RESPONSE TO QUERIES AND COMMENTS RAISED DURING THE MÔR HAFREN BIO POWER LIMITED CONSULTATION AIR QUALITY ISSUES ADDRESSED BY ENVIRONMENTAL VISAGE LIMITED

This brief report addresses the air quality and assessment related queries and comments raised in various responses to the consultation issued by the Planning Inspectorate, for Development of National Significance reference DNS/3236340. The application refers to the proposed Môr Hafren Bio Power Limited (MHBP) Energy Recovery Facility to be based off Newlands Road in Trowbridge.

Figure 1 The Local Setting Showing the Location of the ERF Development Site

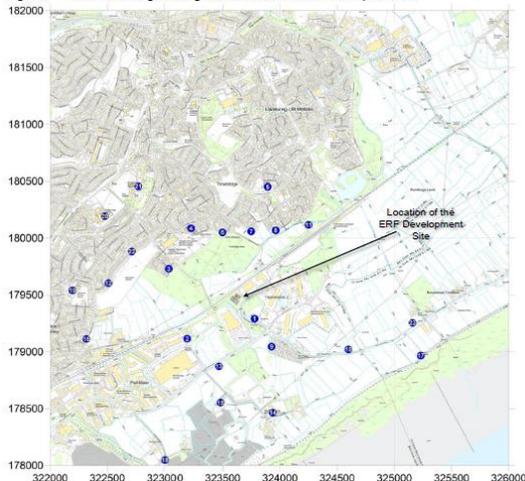
It is not clear whether the applicant has specifically considered the potential impact of the emissions of pollutants on the communities and residential properties of Rumney, Trowbridge, St Mellons, Peterstone, Marshfield and Castleton. Specific concerns were raised regarding the fact that the Health Impact Assessment provides no modelling results for the 20 primary and secondary schools in the surrounding area, along with other concerns about the chosen receptors.

Mr Alderman has questioned why Receptor Number 20 includes the old site for Eastern High secondary school when the site moved to a new location in January 2018.

A number of discrete sensitive receptors were identified which included the nearest of these identified areas and a selection of the schools in the vicinity (see diagram and list below, which were also included in the Air Quality Assessment, and note that these have been updated in Version 7 of the assessment). However, additionally, the use of the modelling grid enables contour plots to be produced which cover wider areas (4 km x 4 km) and show the levels of contributions in these areas, albeit in more general terms, rather than with detailed concentrations at specific points.

With regard to the original modelling of Eastern High in a location which has been vacated, we note that, as shown by the respondent's own map, the old school site is still identified on national mapping and, due to a lack of local knowledge, it was not identified that the facility had moved. However, this does not change the fact that, only a selection of discrete receptors has been modelled, with the modelling grid providing information across the wider area, and this would include the new site for Eastern High. As the maximum Process Contributions across the entire modelled grid are screened as insignificant at either the initial or secondary assessment stage, it is not considered necessary to include every individual potentially sensitive property or location as a discrete receptor.
